PARK CITY MUNICIPAL CORPORATION
ADMINISTRATIVE ACTION MEETING MINUTES
PLANNING DEPARTMENT
March 28, 2024
<https://us02web.zoom.us/j/88167820277>

516 Marsac Avenue – Historic District Design Review – PL-23-05724 – The Applicant Proposes to Construct a 147 Square Foot Addition to an Existing Non-Historic Structure in the Residential - 1 Zoning District.

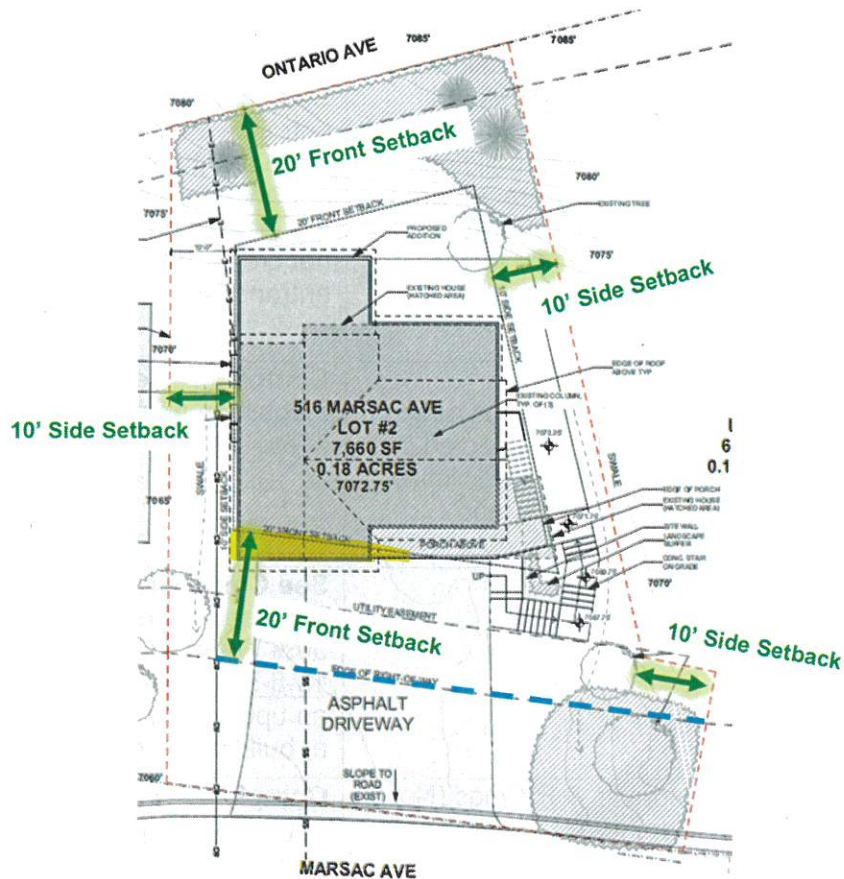
9. As the Lot has six sides, and fronts two public Rights-of-Way, the Planning Director determined the Setbacks for the Lot, illustrated below:
